ADDENDUM No. 3
FOR
LINK – Multi-Use Development
BID PACKAGE – All Trades

Date of Issue: April 24, 2023

LINK – Addendum #3 Narrative

4/21/23

UNIT 0J
S152 1/4" = 1'-0"

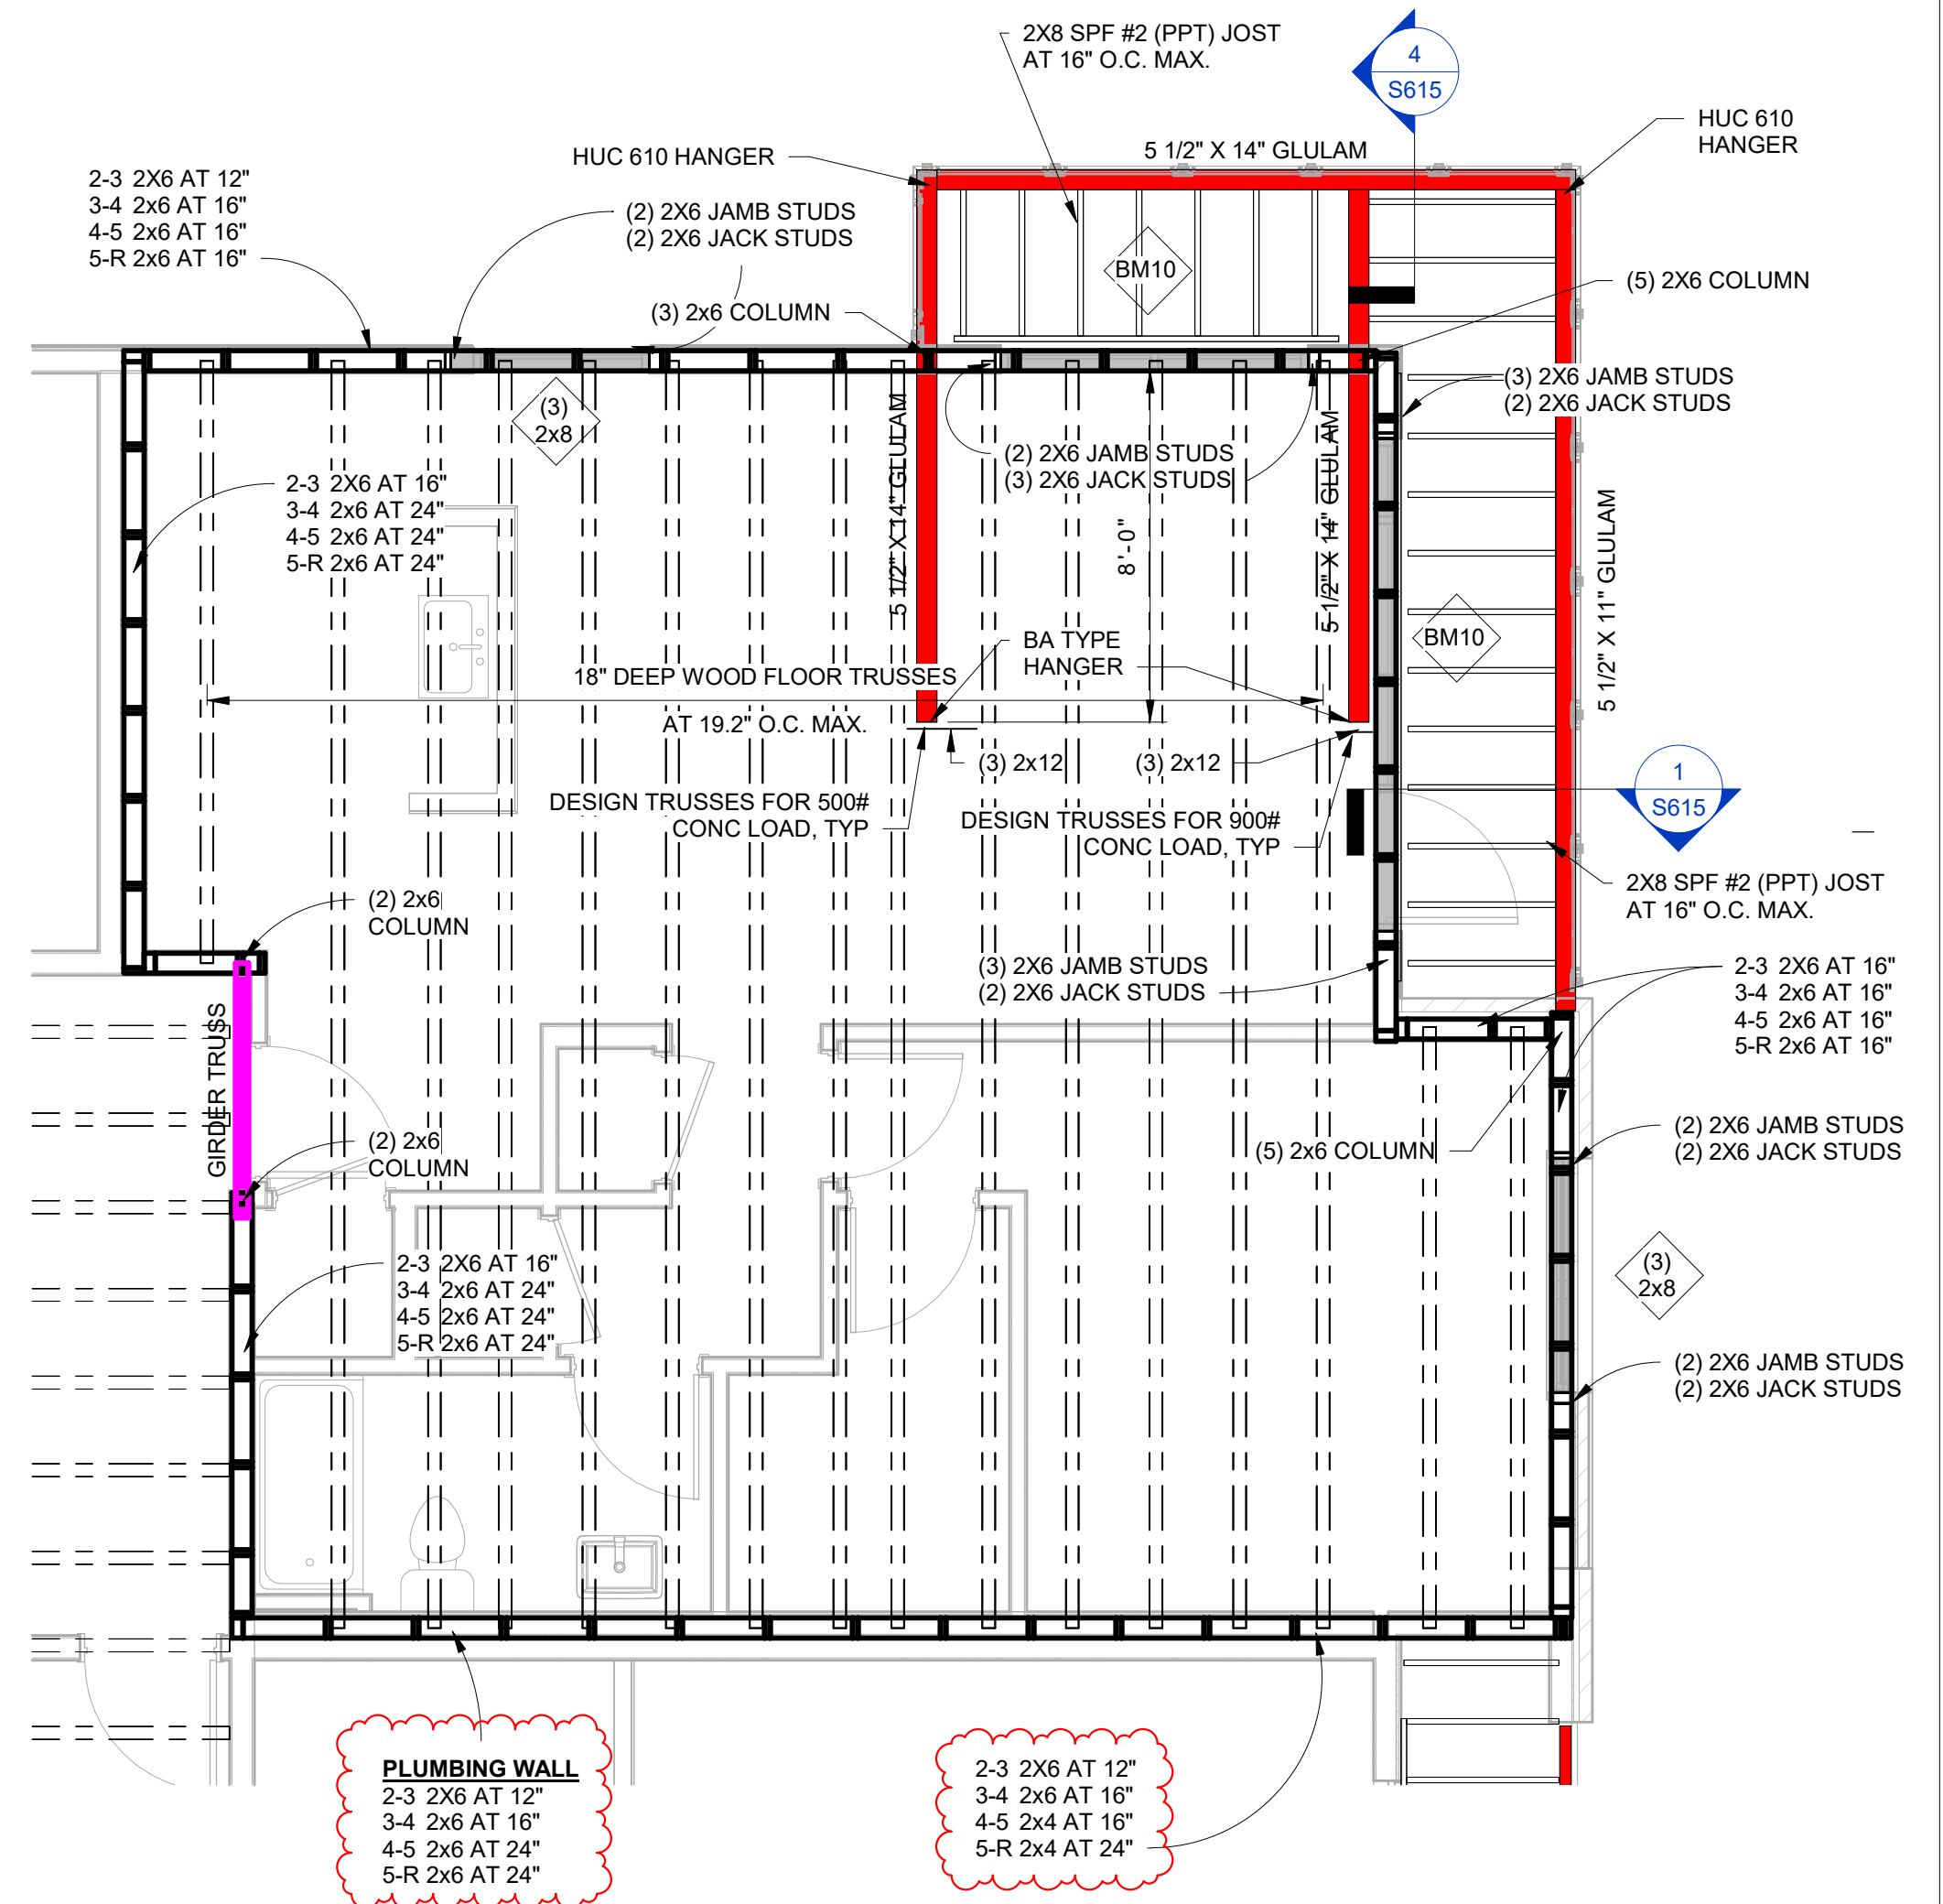
- S152
 - Revised studs at upper floor demising walls to 2x4 studs where indicated.
 - S153
 - Revised studs at upper floor demising walls to 2x4 studs where indicated.

7 STAIR 2 - ISOMETRIC

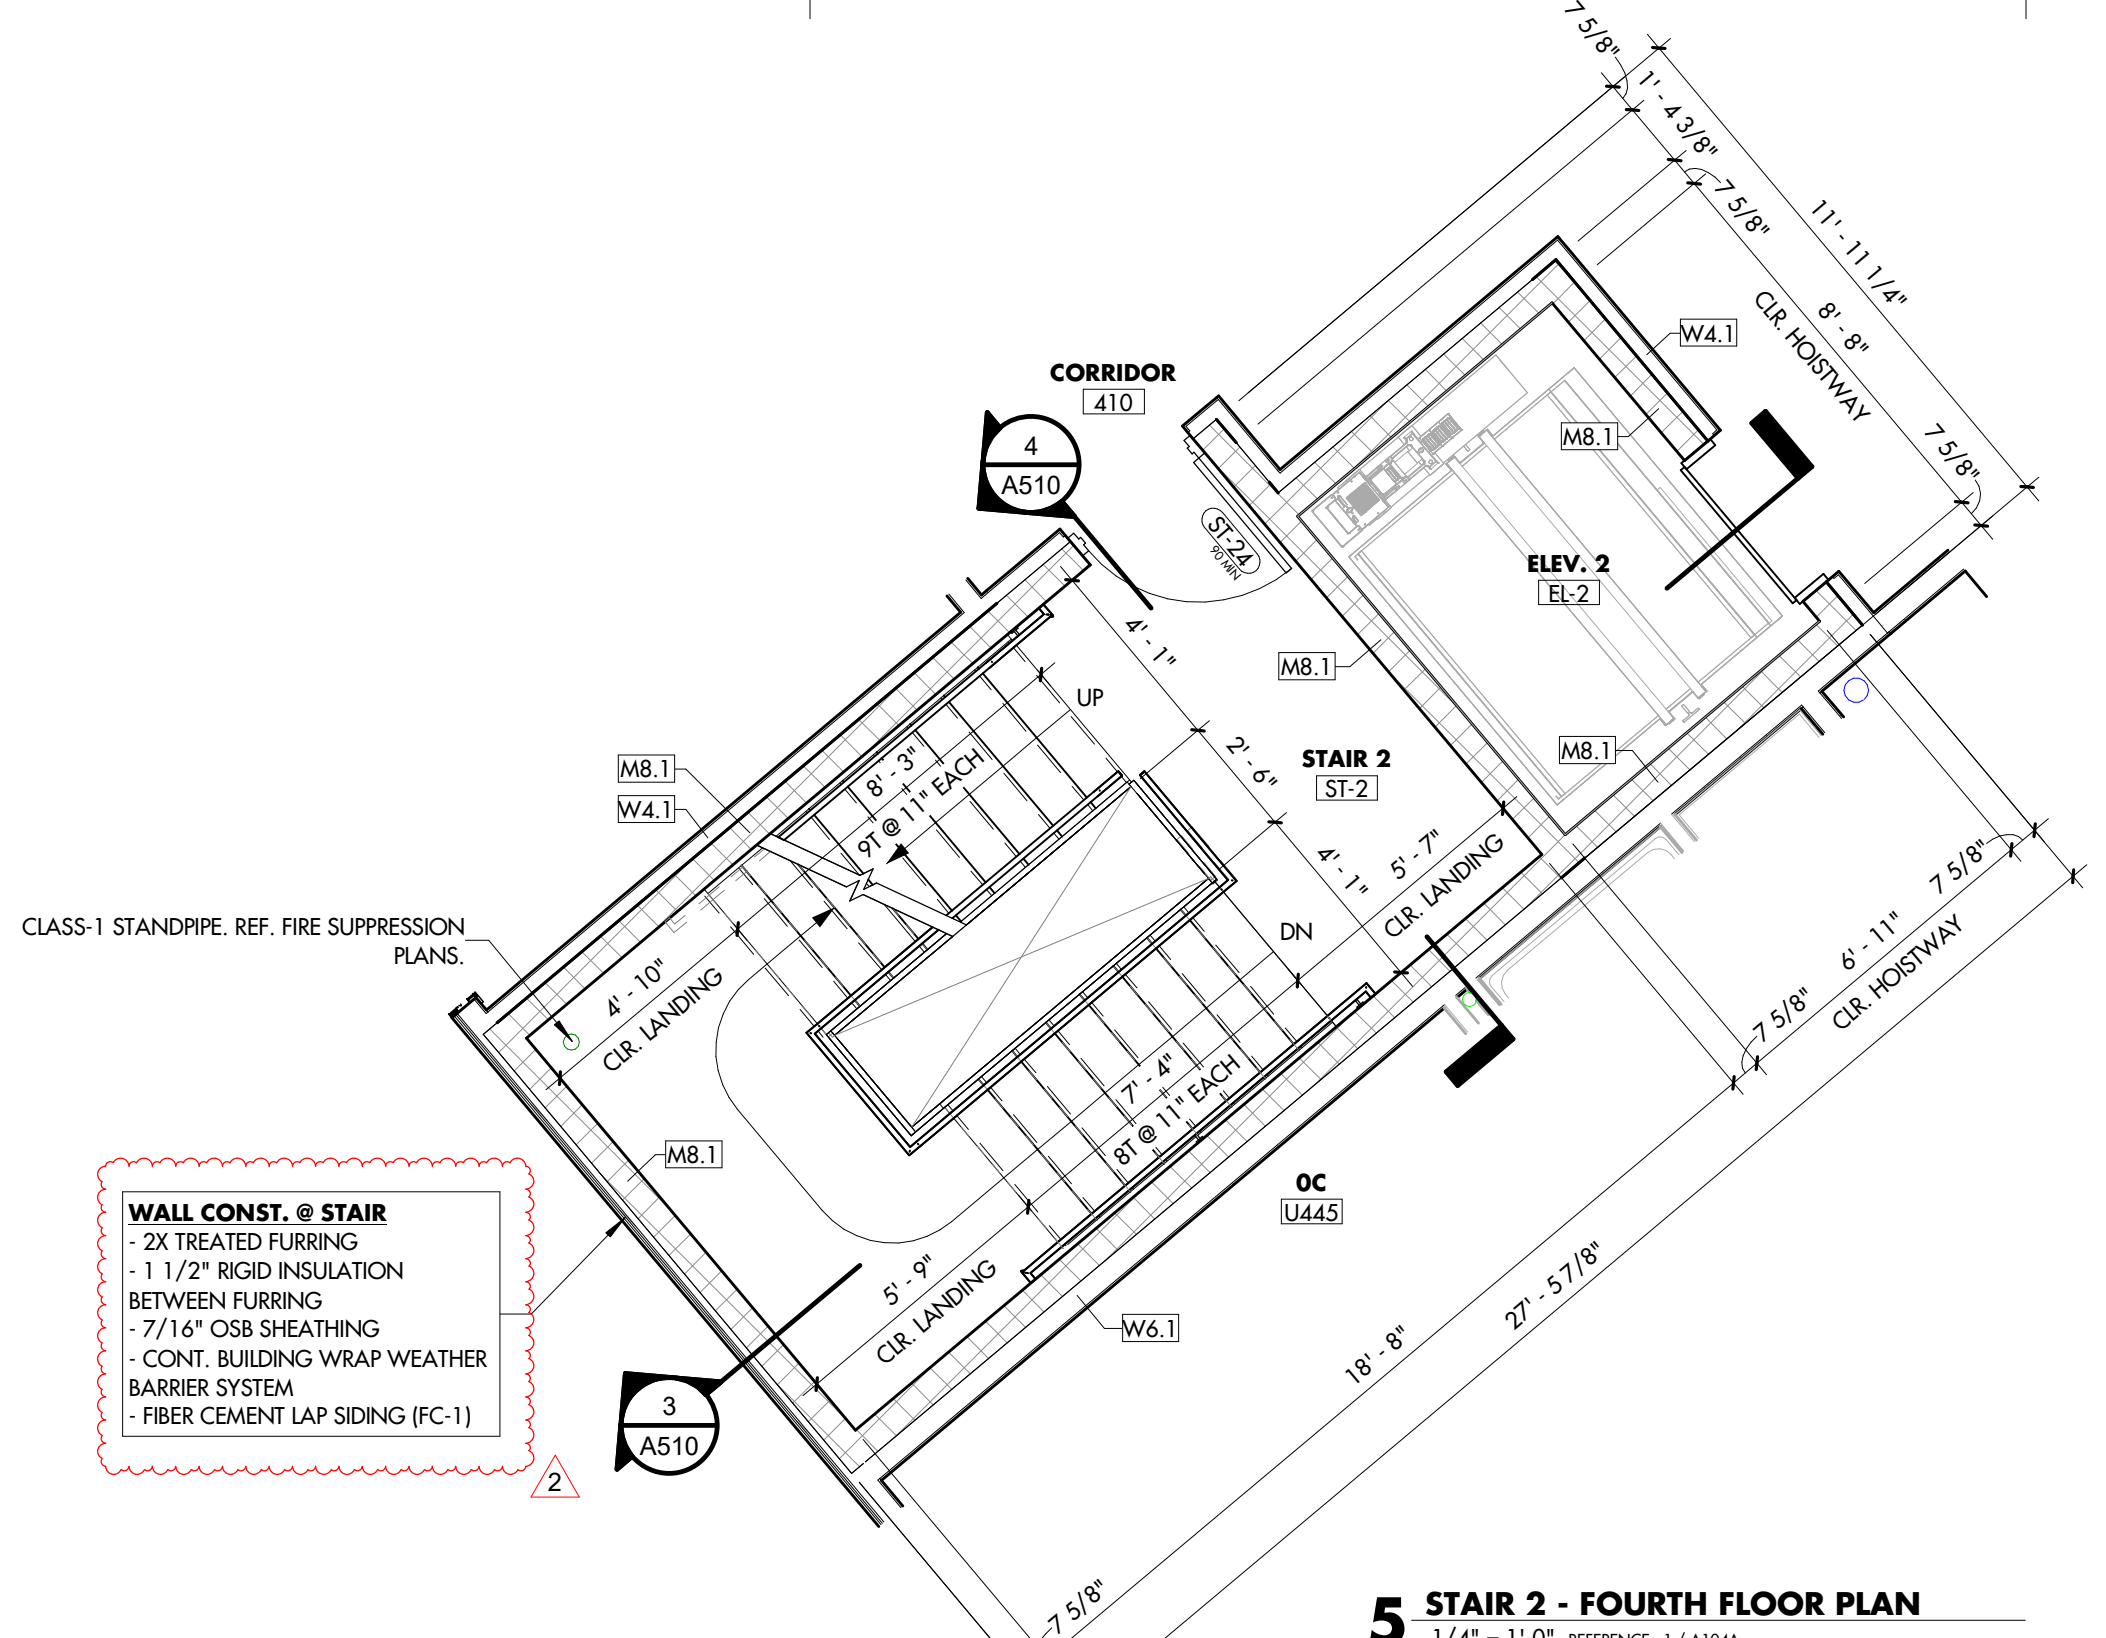
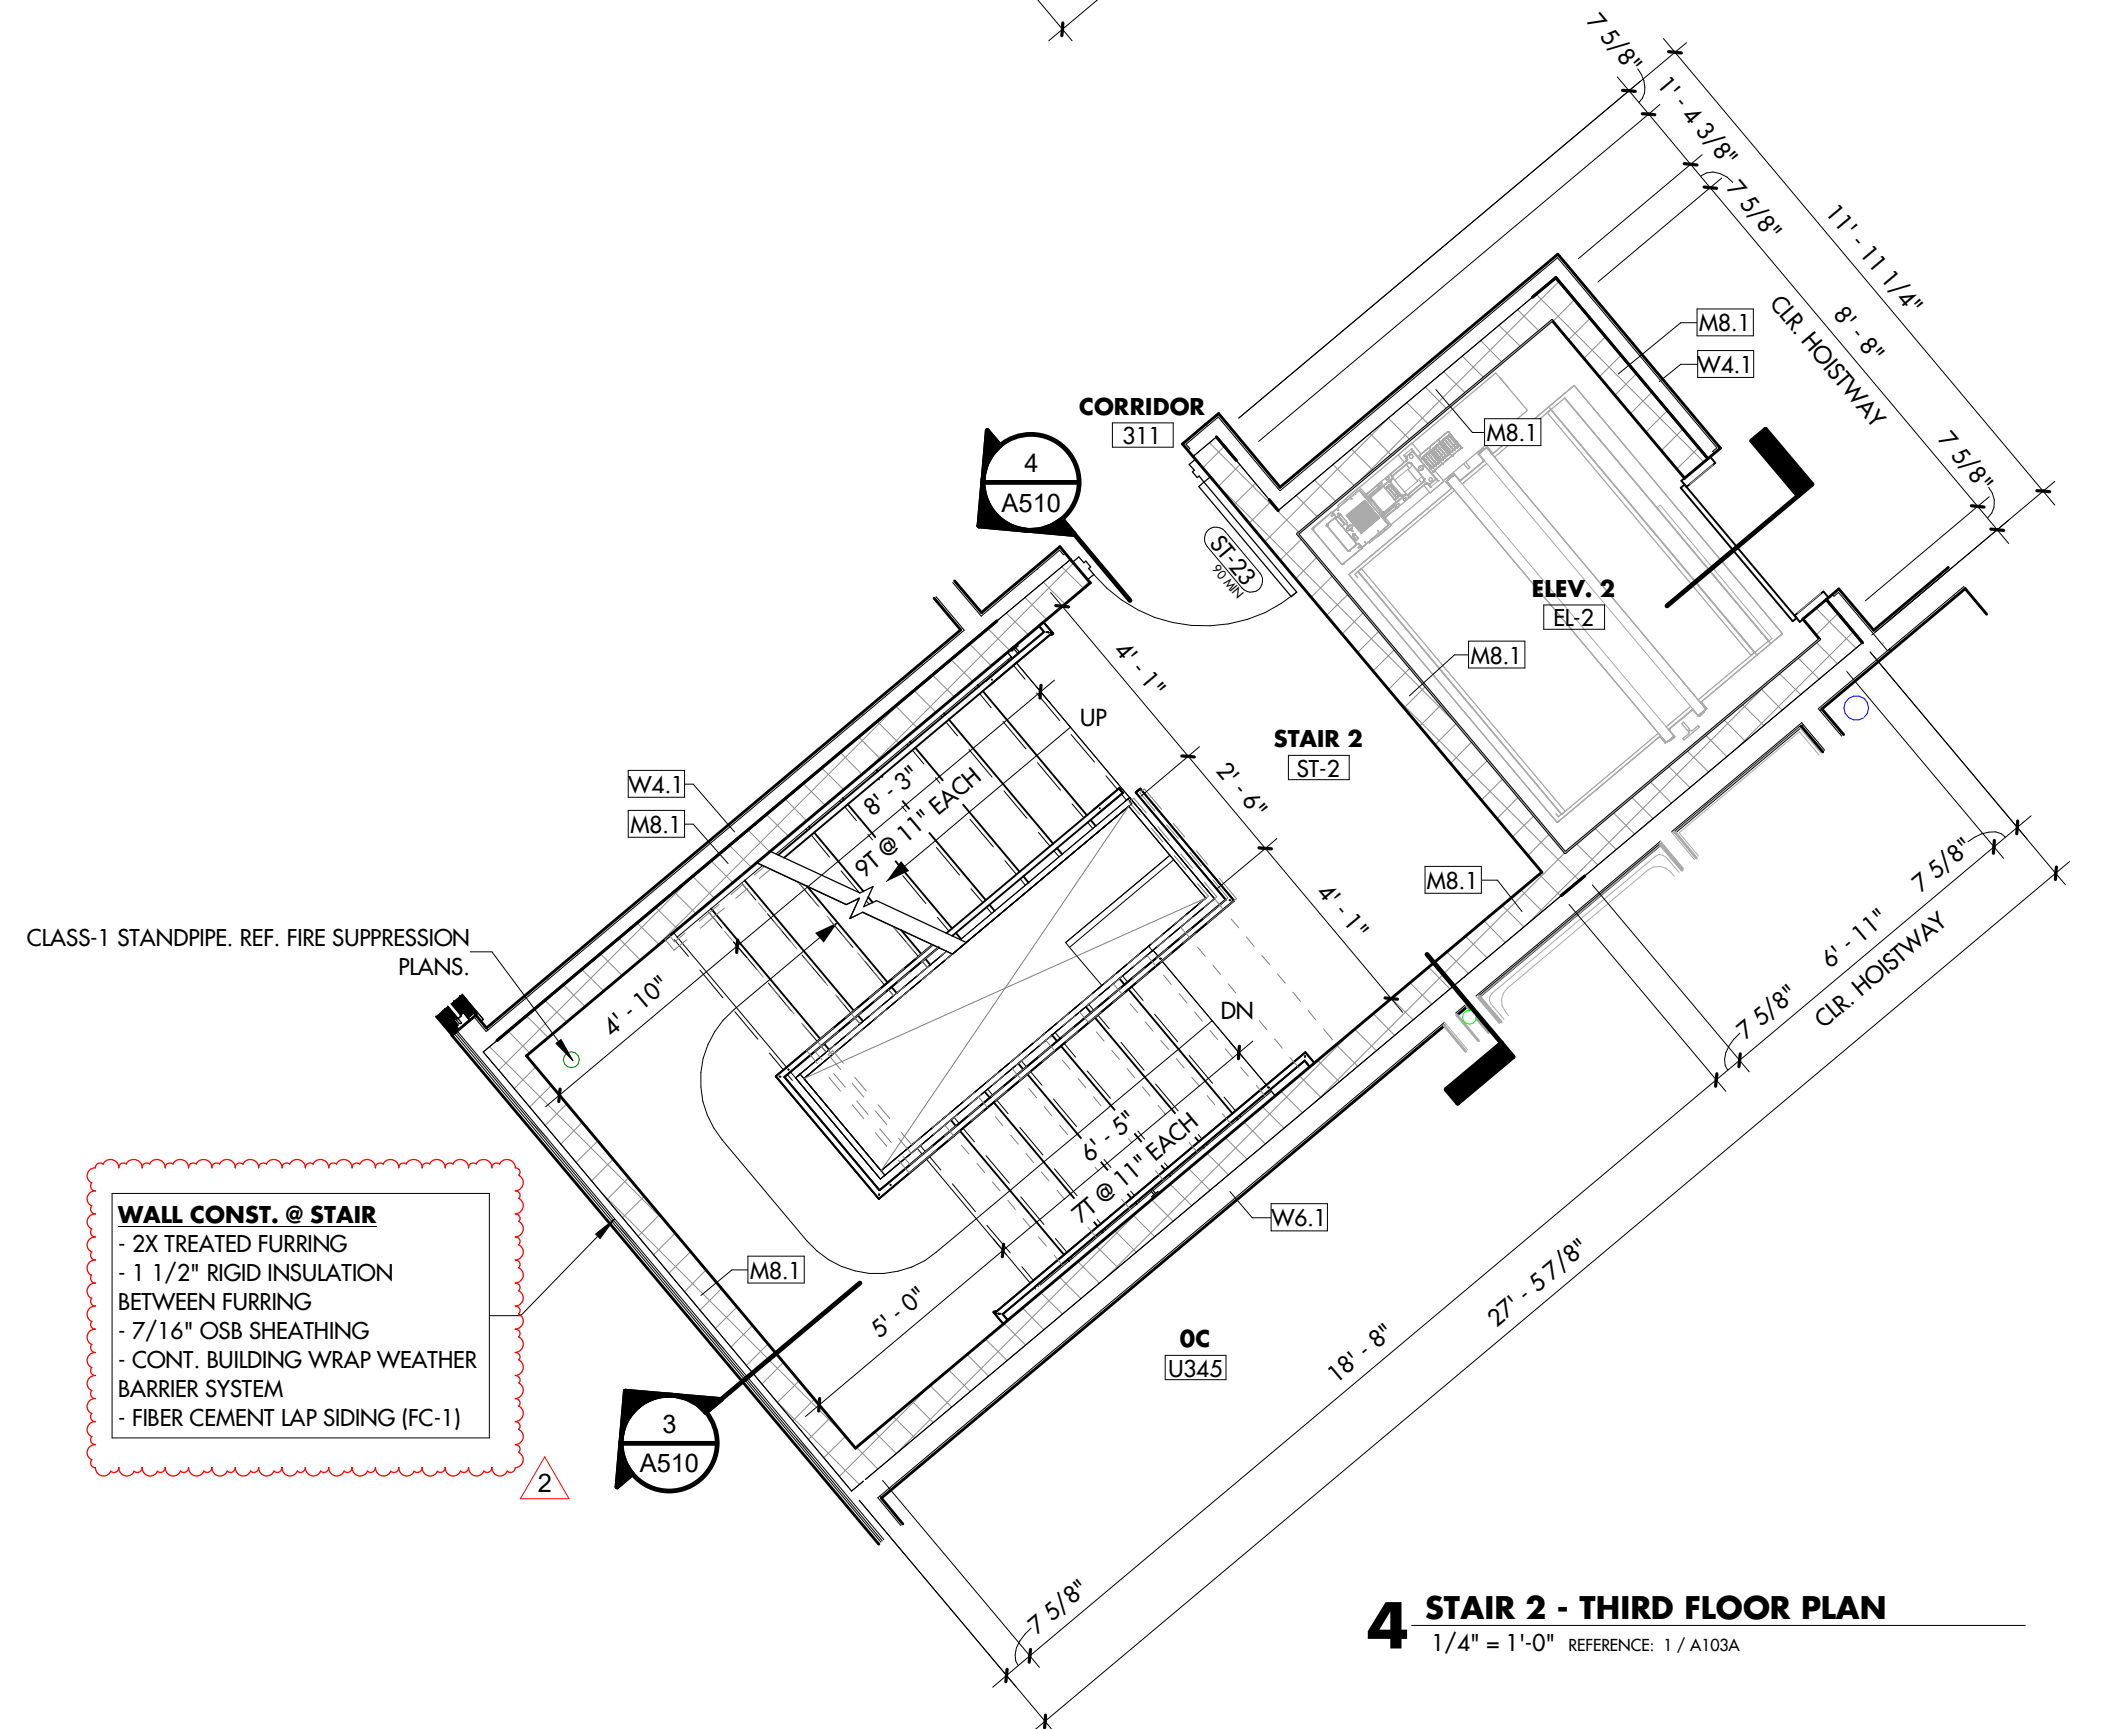
- A504
 - Clarified exterior wall construction at stair.
- A601
 - Revised door finishes.
- A602
 - Revised door finishes.
 - Revised pre-hung unit door heights.
